Grading Plan Approved
as shown and/or noted
THOMAS P. GILLES, P.E.
Lake County Engineer

SITE PLAN

for : Charles Pengal (CLIENT)

11702 (ADDRESS) Cali Court (STREET) Concord Twp. (CITY)

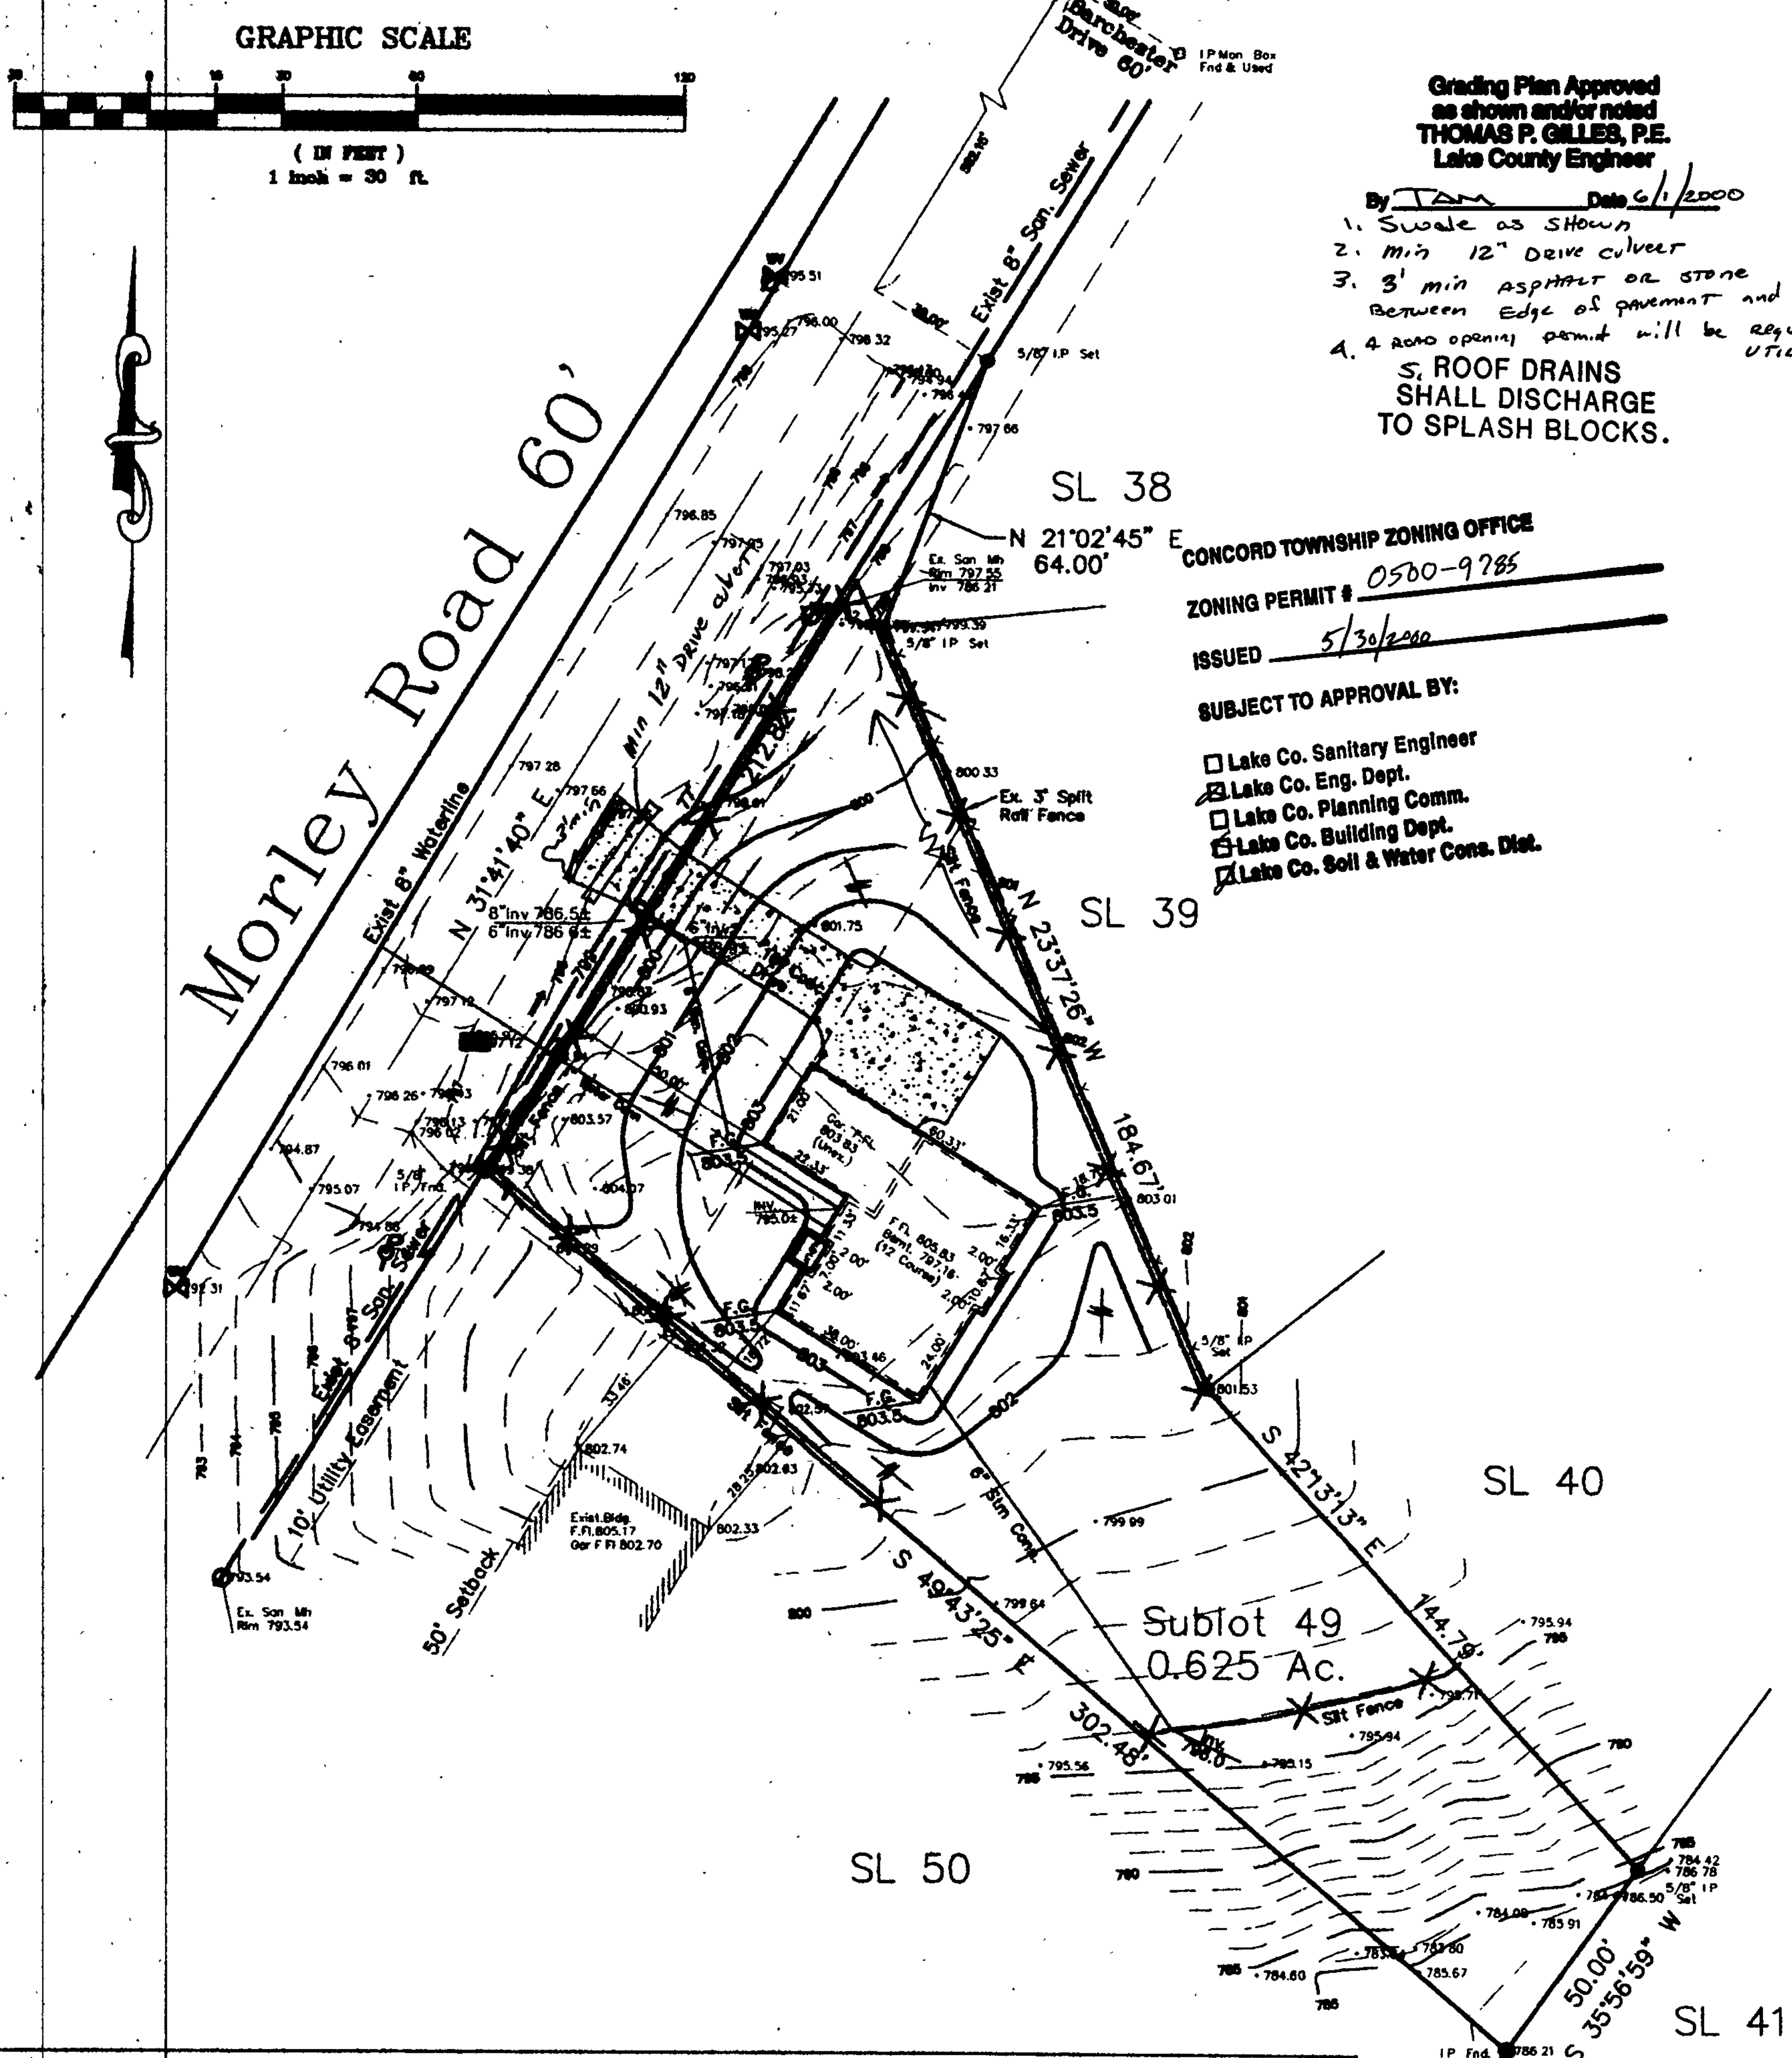
By TAM Date 6/1/2000
1. Swale as shown
2. min 12" Drive culvert
3. 3' min asphalt or stone between edge of pavement and concrete
4. A road opening permit will be required for utility work in R/W
5. ROOF DRAINS SHALL DISCHARGE TO SPLASH BLOCKS.
